UNITED STATES PATENT AND TRADEMARK OFFICE

APPLICATION NO.	FILING DATE	FIRST NAMED INVENTOR	ATTORNEY DOCKET NO.	CONFIRMATION NO.
10/671,273	09/24/2003	Chin-Hsien Yen	JCLA9302	6552
23900	7590	04/20/2005	EXAMINER	
J C PATENTS, INC. 4 VENTURE, SUITE 250 IRVINE, CA 92618			ENGLUND, TERRY LEE	
			ART UNIT	PAPER NUMBER
			2816

Office Action Summary

DETAILED ACTION

FIG. 1A (PRIOR ART)

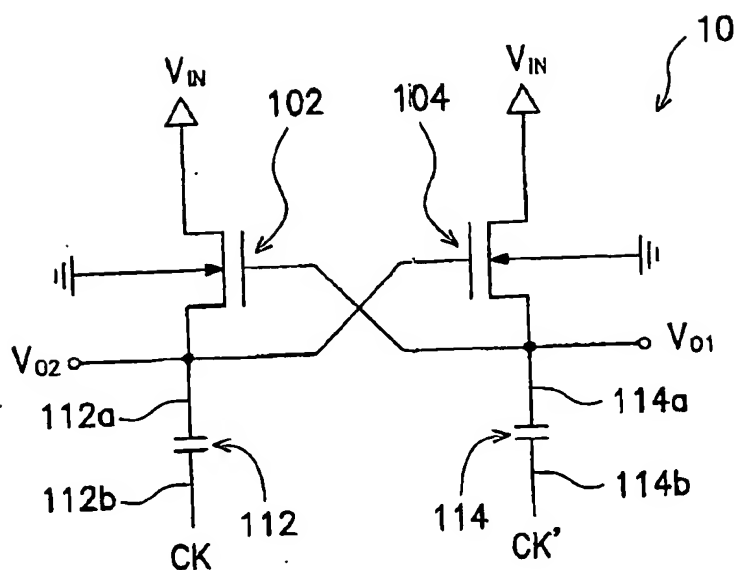
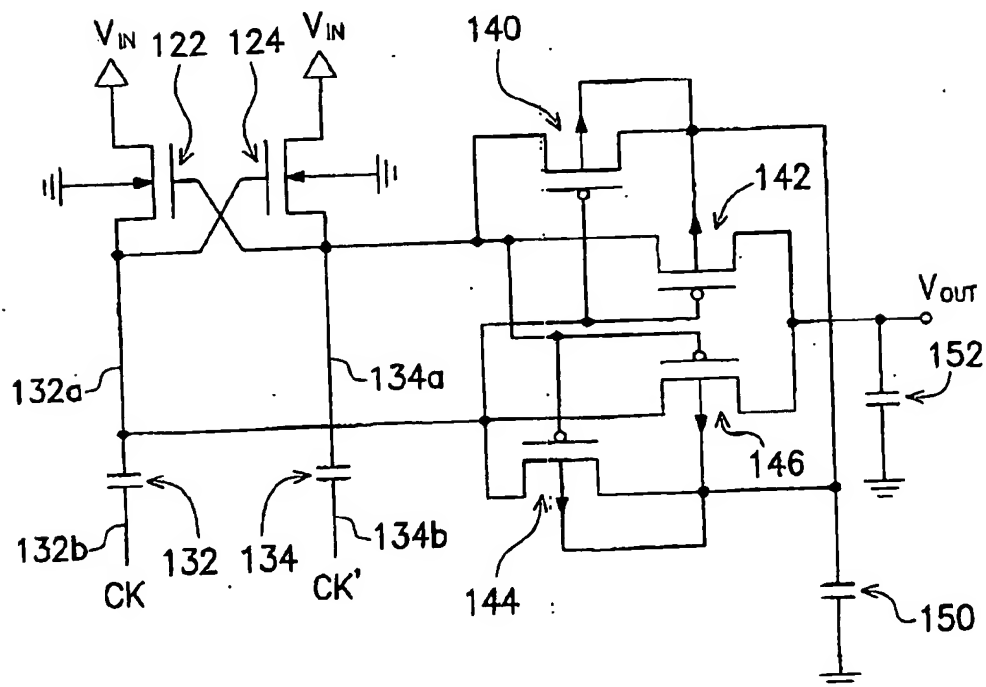
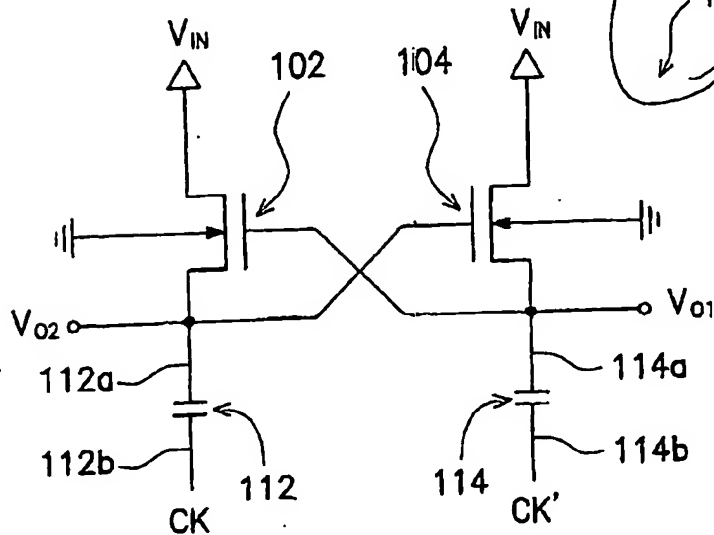
Although the drawing change to Fig. 1A, and a change to the disclosure with respect to Fig. 4, overcame the objections with respect to Figs. 1A and 4 lacking the reference signs "10" and "440b", respectively, the other drawing objections described on page 2 of the previous Office Action were not addressed/corrected. Therefore, the "10"/"440b" objections have been withdrawn, but the other objections are maintained. These remaining objections are repeated later under the appropriate section.

Approved
4.8.05
TLE

FIG. 1B (PRIOR ART)

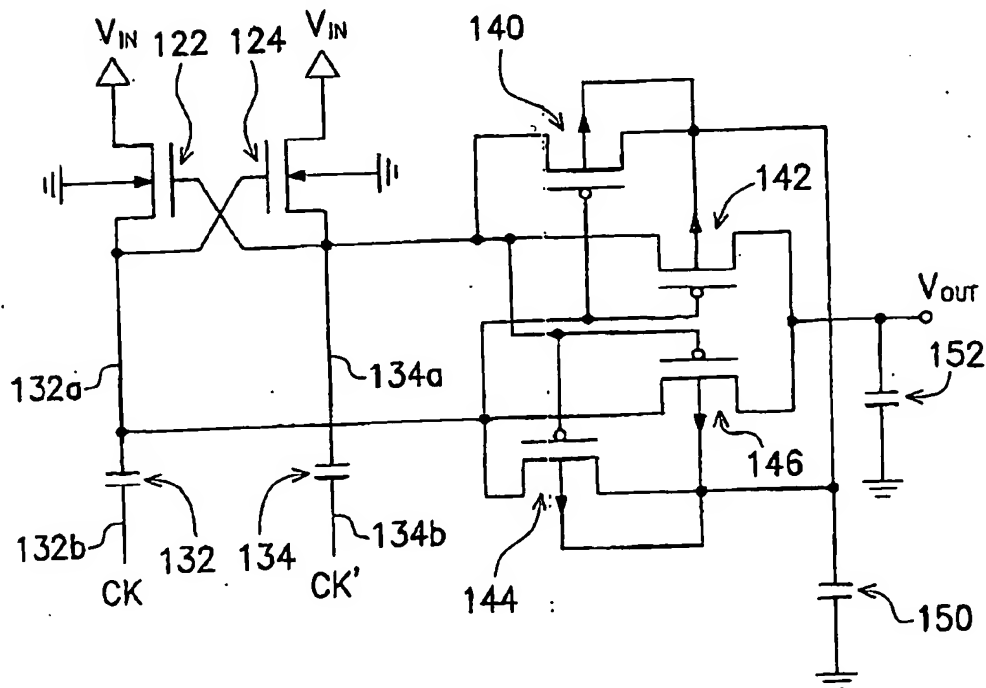
The drawings remain objected to as failing to comply with 37 CFR 1.84(p)(5) because they include the following reference character(s) not mentioned in the description: 132, 132a, 132b, 134, 134a, 134b, and 140-152 with respect to Fig. 1B; 32, 302, 304, 308, 322, 330, and 332 with respect to Fig. 3; and 502-508, 512-518, 530, and 540 with respect to Fig. 5. Corrected drawing sheets in compliance with 37 CFR 1.121(d), or amendment to the specification to add the reference character(s) in the description in compliance with 37 CFR 1.121(b) are required in reply to the Office action to avoid abandonment of the application. Any amended replacement drawing sheet should include all of the figures appearing on the immediate prior version of the sheet, even if only one figure is being amended. The replacement sheet(s) should be labeled "Replacement Sheet" in the page header (as per 37 CFR 1.84(c)) so as not to obstruct any portion of the drawing figures. If the changes are not accepted by the examiner, the applicant will be notified and informed of any required corrective action in the next Office action. The objection to the drawings will not be held in abeyance.

NOT APPROVED
4.8.05
TLE
